INCH POUND
MIL-PRF-19500/698
AMENDMENT 1
22 January 2002

PERFORMANCE SPECIFICATION

SEMICONDUCTOR DEVICE, FIELD EFFECT RADIATION HARDENED (TOTAL DOSE AND SINGLE EVENT EFFECTS) TRANSISTOR, N-CHANNEL, SILICON TYPES 2N7470T1 AND 2N7471T1 JANTXVR, F, G AND H AND JANSR, F, G AND H

This amendment forms a part of MIL-PRF-19500/698, dated 16 August 2001 and is approved for use by all Departments and Agencies of the Department of Defense.

FIGURE 4. Safe operating area graph (2N7471T1).”

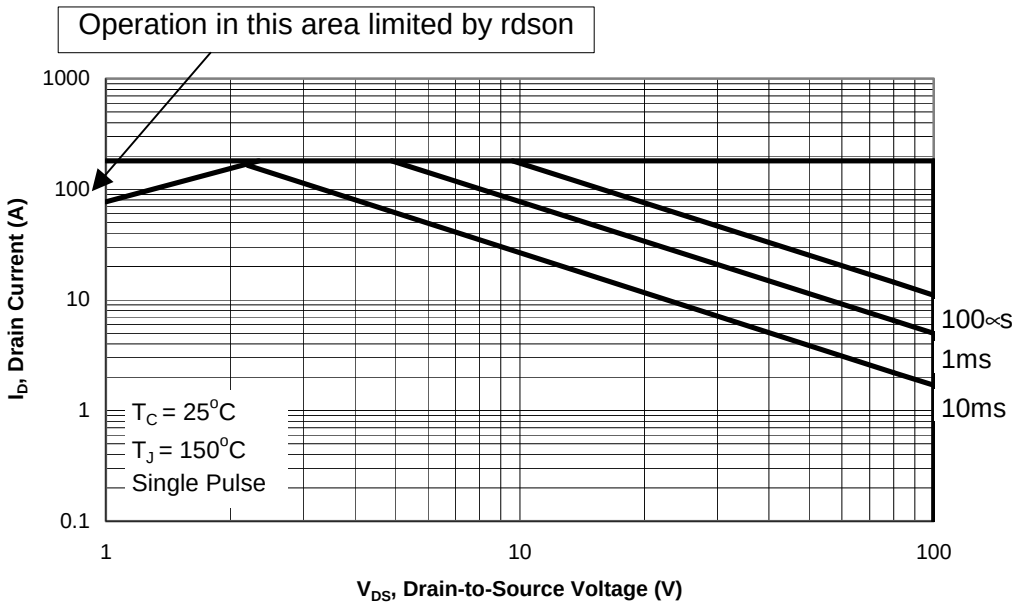
FIGURE 4, delete and substitute:

FIGURE 5. SEE safe operating area graph.”

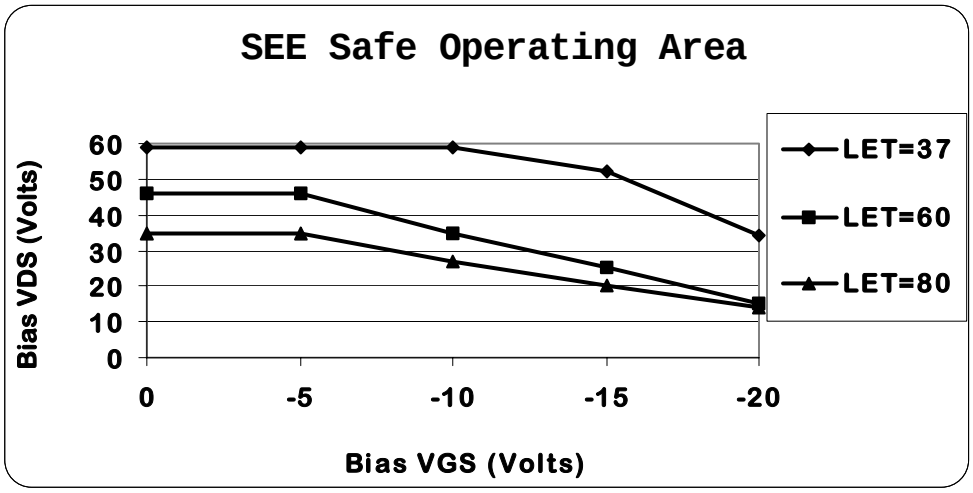
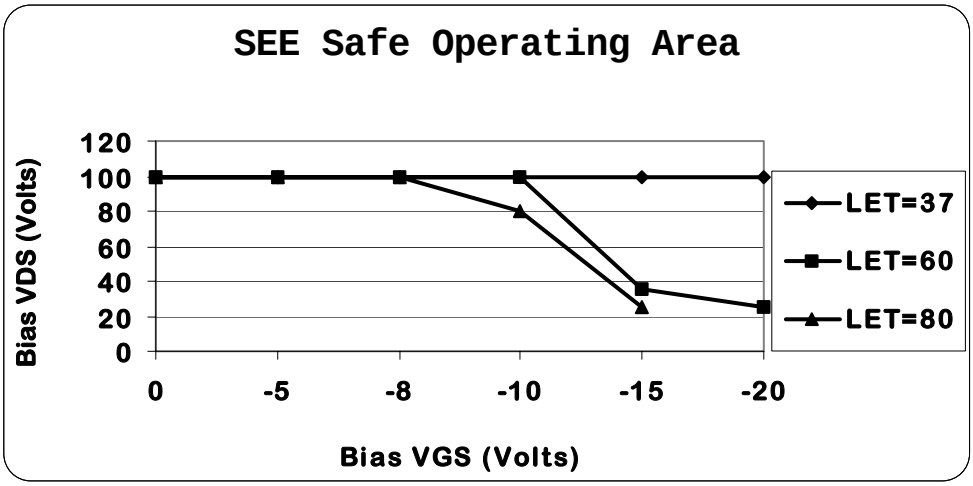
FIGURE 5, delete and substitute:
